September 18, 2002

To: T10 Technical Committee  
From: Timothy Hoglund (LSI Logic)  
Subject: SAS Expander update

This proposal is an update to SAS expander definition including a refinement of the Expander device model (section 4.8) and an update to the XL state machine (section 7.13.3).

Figure 1. Expander device model

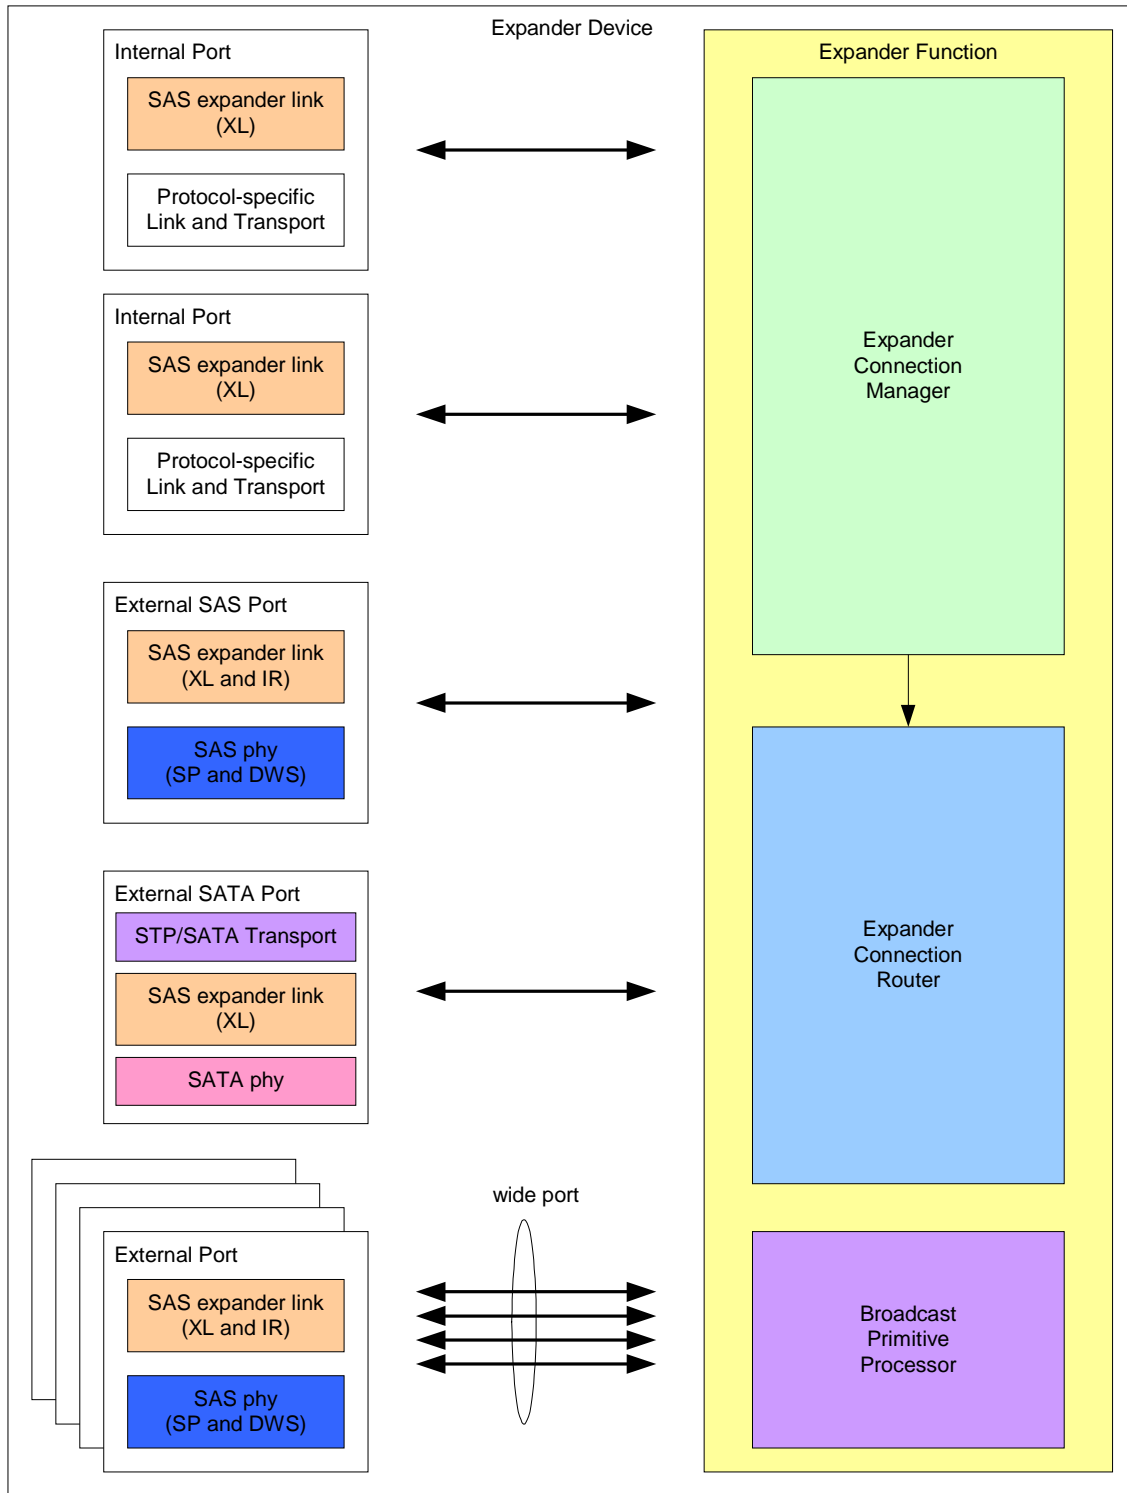
- 1) updated expander device model
- 2) move PPT timers from Expander Function to XL state machine
- 3) expander interface signal descriptions
- 4) updates to XL state machine
- 5) add text below to 7.12.3 Arbitration fairness

An expander device shall contain the following ~~components~~:

An expander device may contain the following ~~components~~:

**Figure 32. Expander interfacesinterface detail**

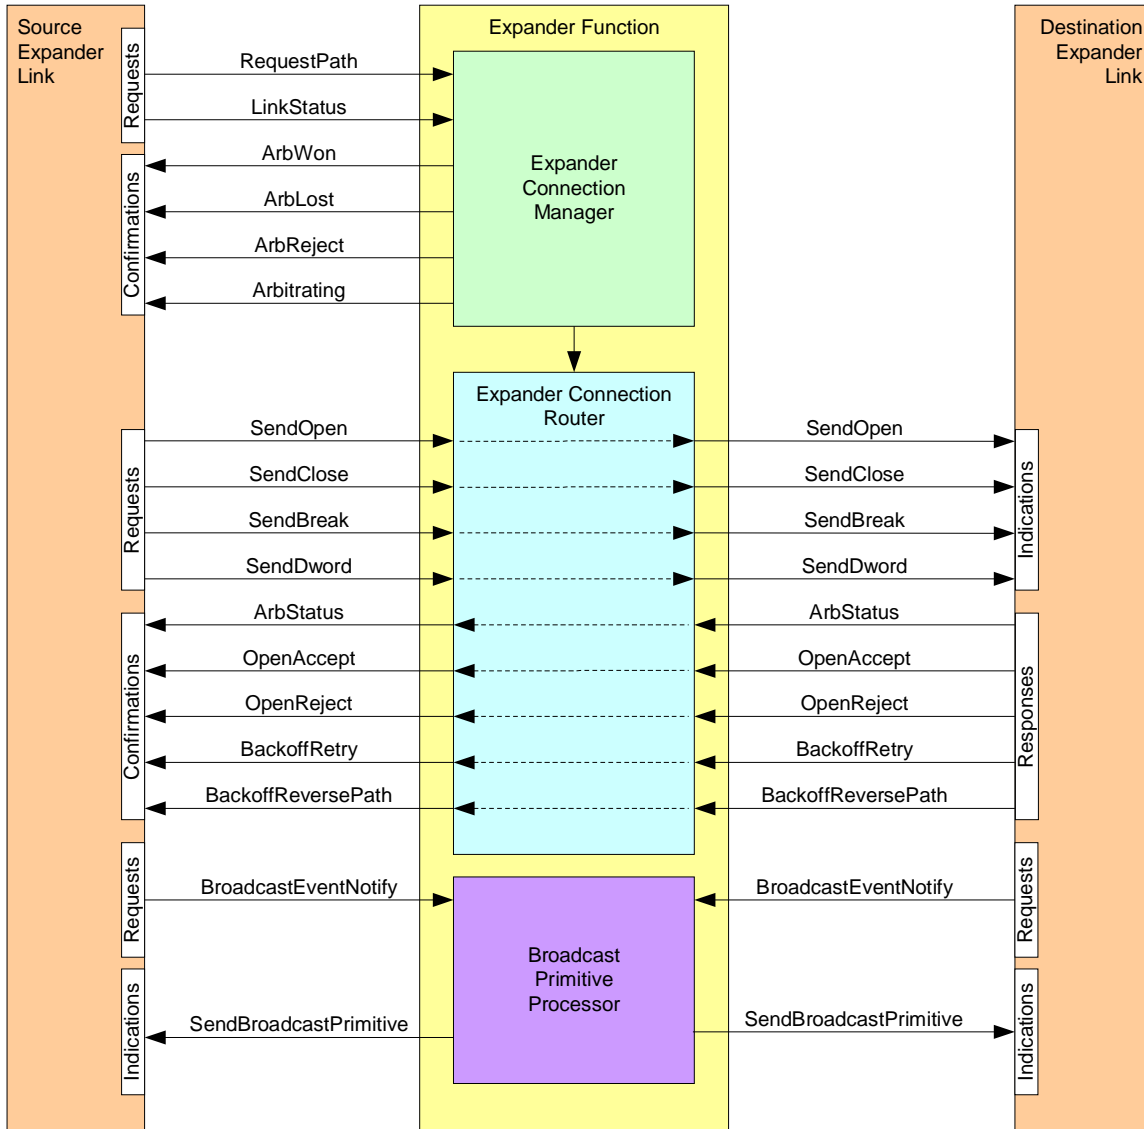
**4.8.74.8.8 Expander interface overviewdetail**

Figure 32 shows the interface requests, confirmations, indications, and responses used by an expander device to manage connections.

**Figure 43. SAS Expander Connection state diagram**

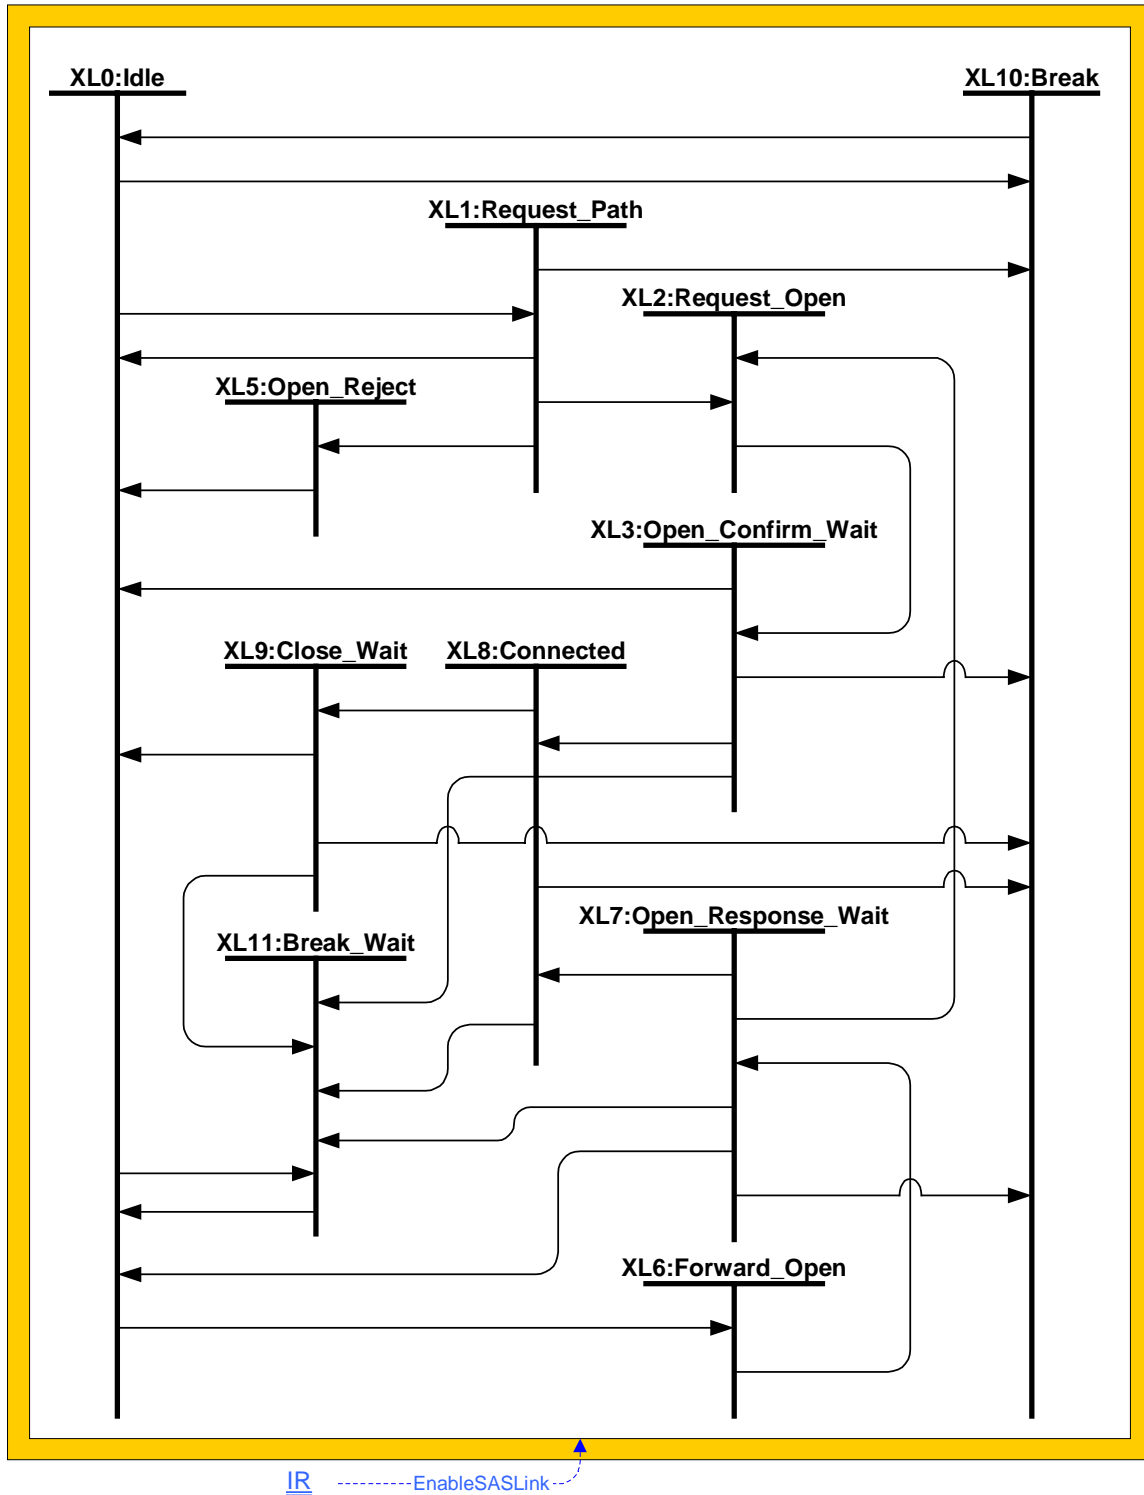
The XL1:Request\_Path state shall initialize a partial pathway timeout timer to PPTOV microseconds (see ~~X.Y7.12.3~~) and shall decrement the timer ~~once per microsecond~~, until reaching zero, while the Arbitrating(Blocked On Partial) confirmation is being received from the expander connection manager.

When the Arbitrating(Blocked On Partial) confirmation is not received, the partial pathway timeout timer shall be held at an initial value of PPTOV.

When the partial pathway timeout timer expires, i.e. reaches zero while receiving the Arbitrating(Blocked On Partial) confirmation, timeout status is conveyed to the expander connection manager via the partial pathway timeout status argument in the RequestPath request.
